PLANNING RATIONALE AND DESIGN BRIEF – 1770 HEATHERINGTON

The City of Ottawa's Strategic Housing Projects branch is providing this Planning Rationale in support of a Plan of Subdivision and Zoning By-law Amendment application for a new multi-residential development at 1770 Heatherington Road. The site is in Ward 10 - Gloucester-Southgate, in the Heron Gate area of the city, just south of Walkley Road and north of the Walkley railyards.

Figure 24 18-metre street section

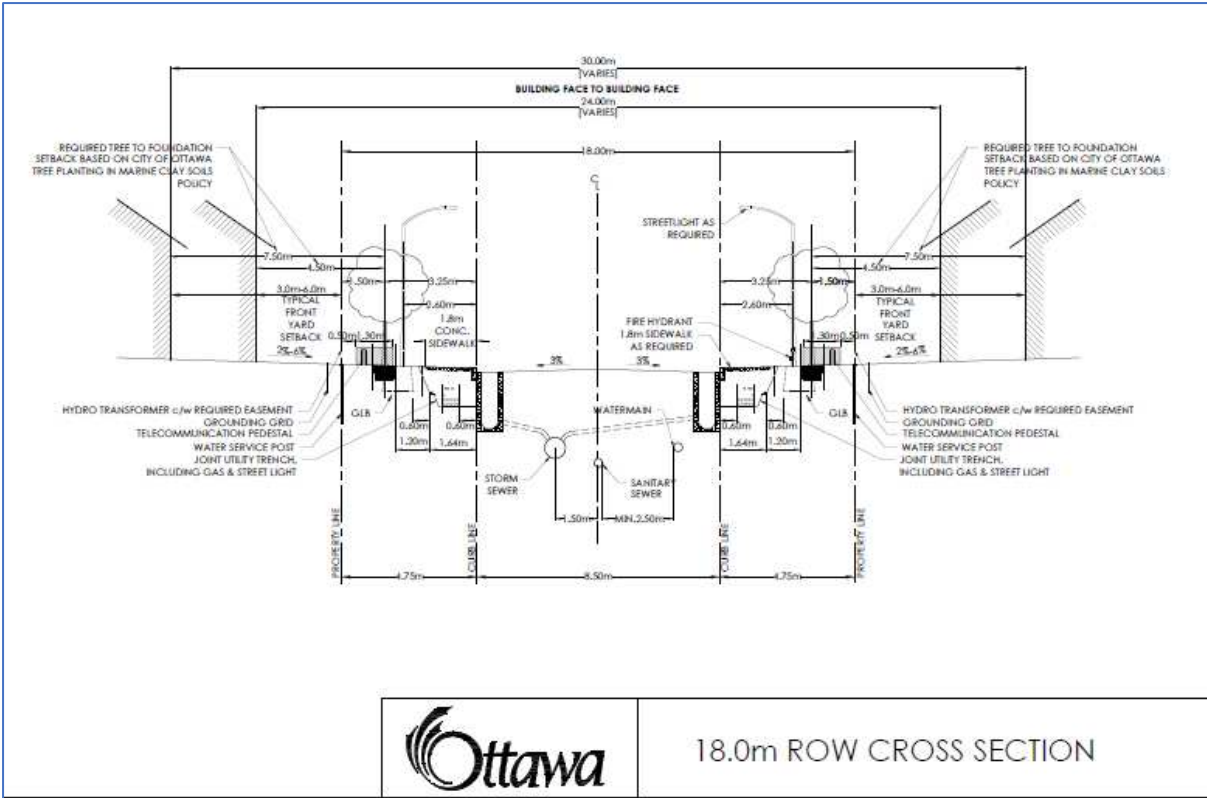
Comment: Provide cross sections for proposed new public road. If only one sidewalk is provided, it is worth discussing/comparing the benefits of the location of the sidewalk on either side of the loop.

Response: The new public road will be 18-metres in width and there will be sidewalks on both sides of the new street with a street tree buffer.

Figure 25 Proposed changes from Urban Design team

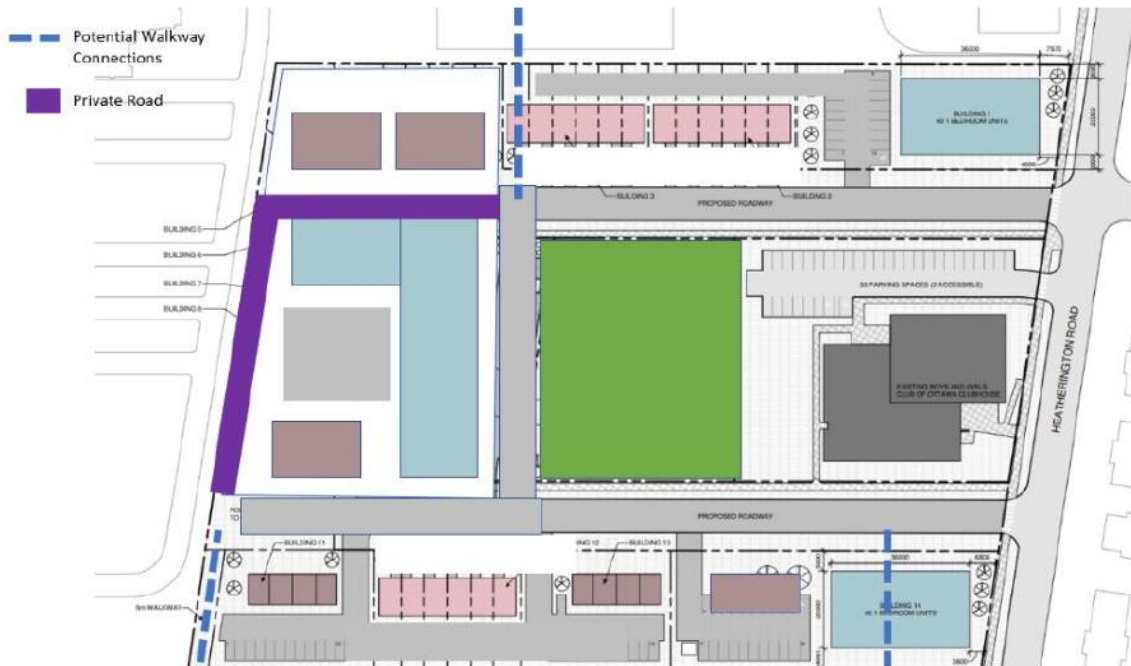
Comment: We appreciate that the proposed interior public road aligns with Fairlea Crescent. Also appreciate the efforts made on the south-west corner of the site to connect to the surrounding community (potential future road connecting to MTO site and the pathway). Please consider revising the scheme to improve the park frontage and to add additional connections (example below)

Response: Thanks for the recommendation, however, we are hesitant to consider a private road with the buildings pushed forward as it may create private areas that are not the most visible to the street (as it was referred to in another comment, CPTED concerns). The aim is to implement a design that focuses on clearly defined public spaces vs. private spaces, 'eyes on the street' and deliberate implementation of CPTED principals.'

Figure 26 Latest subdivision concept plan

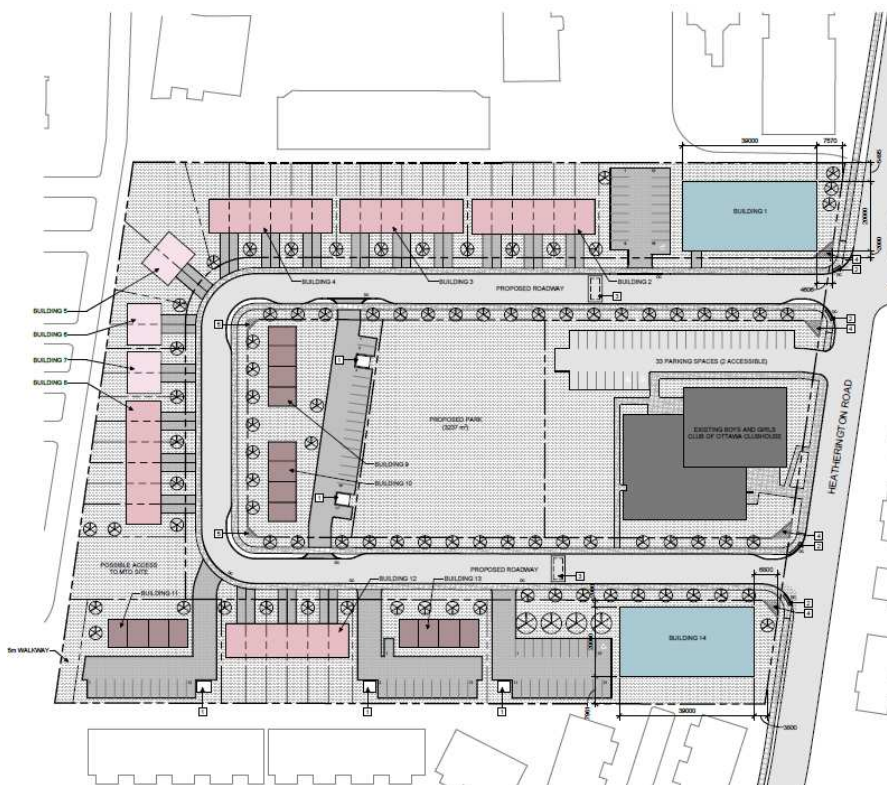
Comment: All parking areas should be located at the rear so that they are not visible from the public realm. Consolidate parking entrances to limit the number of curb cuts. Parking for townhome units should also be accessed via a rear lane.

Response: Our recent concept plans shows that the driveways for the towns will be twinned and they will not have their own driveways, as it was previously shown. Note, we are still proposing towns at this time and a parking space would be required for each dwelling unit if the successful builder would be looking to establish separate ownership. Opportunities for rear lanes will be given further consideration once the individual blocks are being designed.
